## Omaha Public Power District

Director of Nuclear Reactor Regulation  
ATTN: Mr. Robert W. Reid, Chief  
Operating Reactors Branch No. 4  
U. S. Nuclear Regulatory Commission  
Washington, D. C. 20555

Reference: Docket No. 50-285

RESPONSE TO NRC SETPOINT  
METHODOLOGY QUESTIONS

Figure 1.1

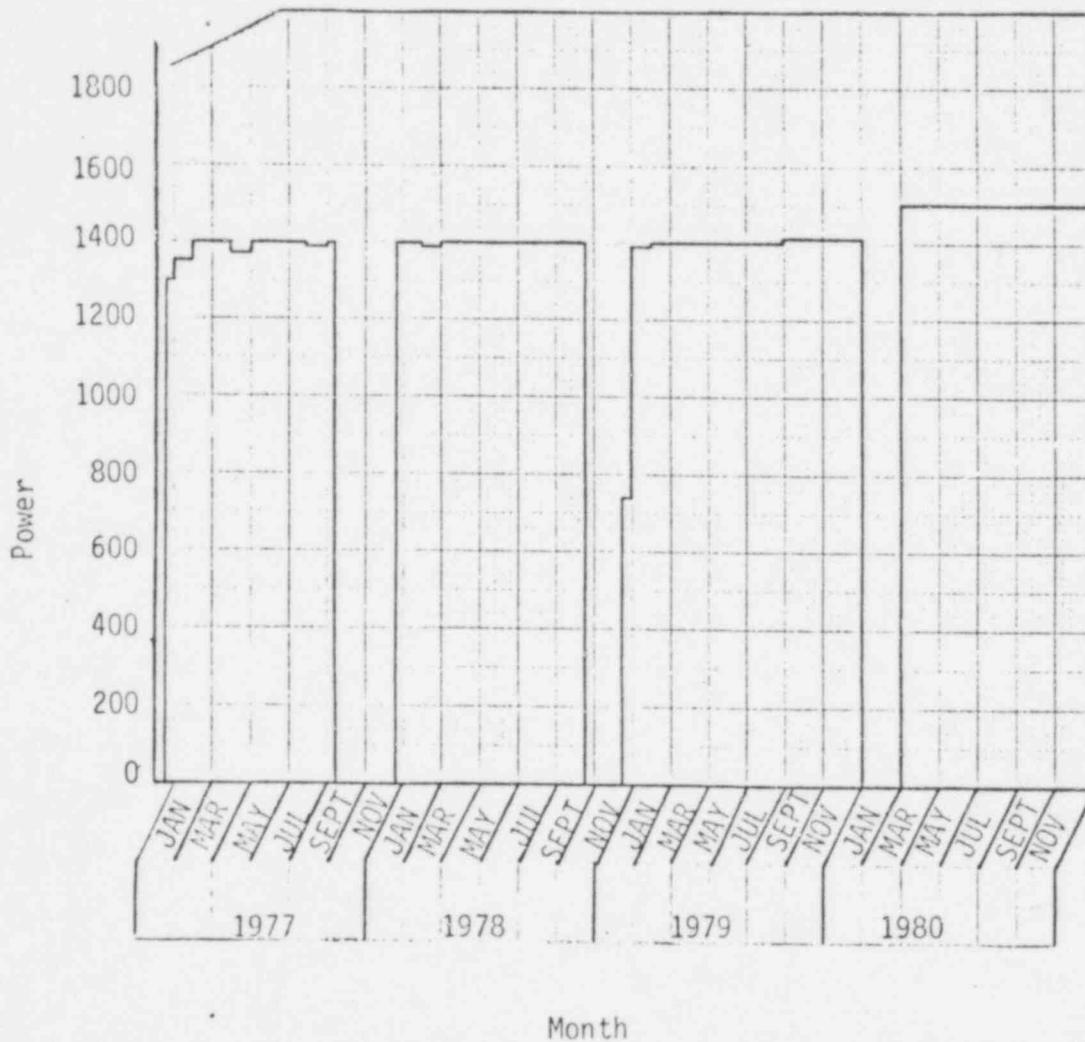
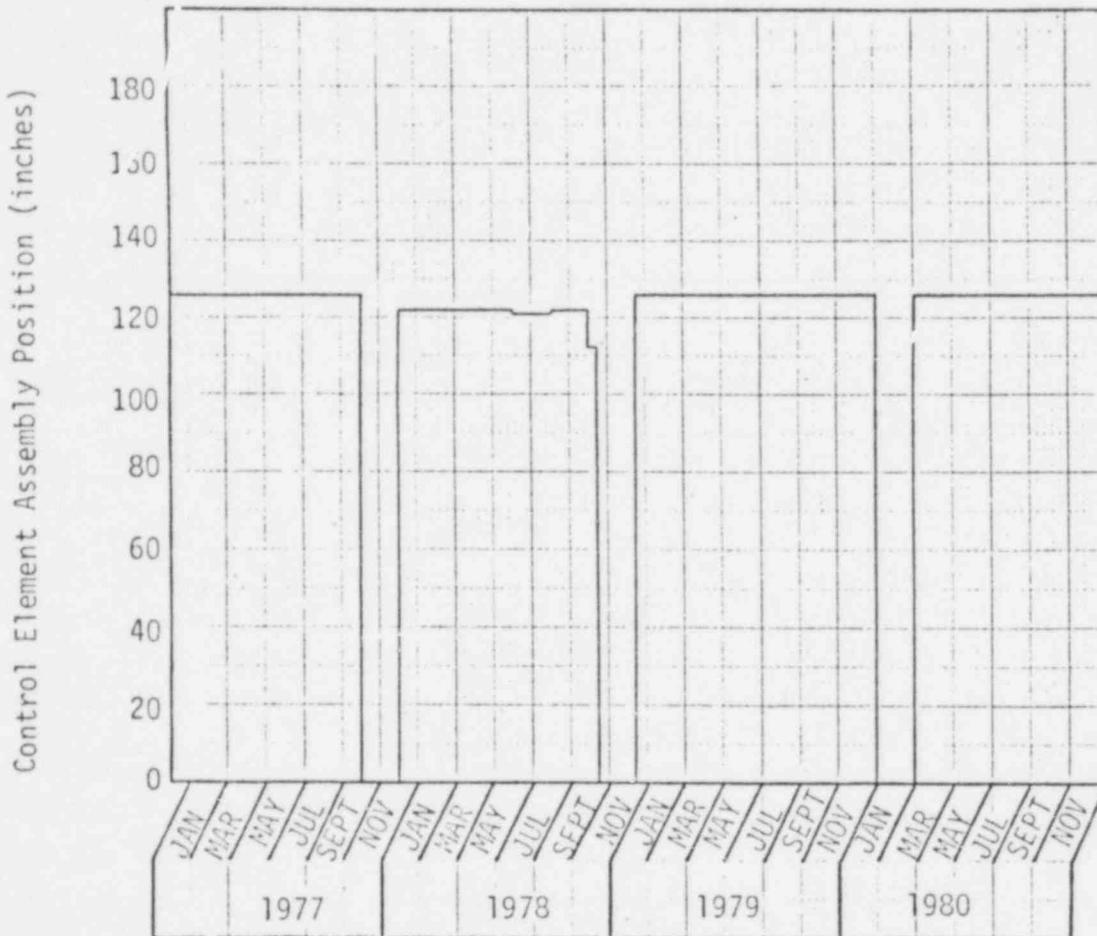
List all operational maneuvers or conditions considered in generating axial power shapes. Also list the control rod configuration and burnup. Describe how the Xenon oscillations were induced.

Also describe whether the plant was base loaded or in a load follow configuration. Give the power history assumed. This information may be provided most efficiently in matrix form.

Justify that only these maneuvers need be considered for generating axial power shapes.

For Ft. Calhoun Cycle 6, how many axial power shapes were generated and how many were used in the set point analysis?

The Fort Calhoun Cycle 6 core was modeled in three-dimensions with the computer code XTG<sup>(1)</sup> and depleted in a base load (1500 MWt) all rods out configuration. This reference power history and rod configuration for Cycle 6 was chosen based on the power and control rod histories of previous cycles (Cycles 3, 4, and 5) and OPPD's anticipated operating requirements for the Fort Calhoun Nuclear Power Plant throughout Cycle 6. (The plant is currently finishing up the 5<sup>th</sup> cycle.) A bar chart showing the actual plant power and control rod configuration by month for Cycles 3, 4, and 5 and the anticipated power and rod histories assumed in the analysis for the determination of Cycle 6 setpoints are shown in Figures 1.1 and 1.2.

Three different burnups, from the three-dimensional XTG Cycle 6 core depletions, were chosen as the base cases for the starting point of more than

1500 axial power profiles generated and used in the determination of Cycle 6 setpoints. The burnups chosen were 0 MWD/MT (equilibrium xenon), 6000 MWD/MT, and 10,000 MWD/MT. The burnups correspond approximately to the beginning, middle and end of the Cycle 6 exposure range. At each of the above mentioned exposure points many possible Cycle 6 axial power profiles were calculated by inducing xenon oscillations. The xenon oscillations were incited by inserting the Control Element Assemblies (control rods or CEA's) to the Power Dependent Insertion Limits (PDIL) at 100% power for 8 hours and then instantly removing the CEA's.
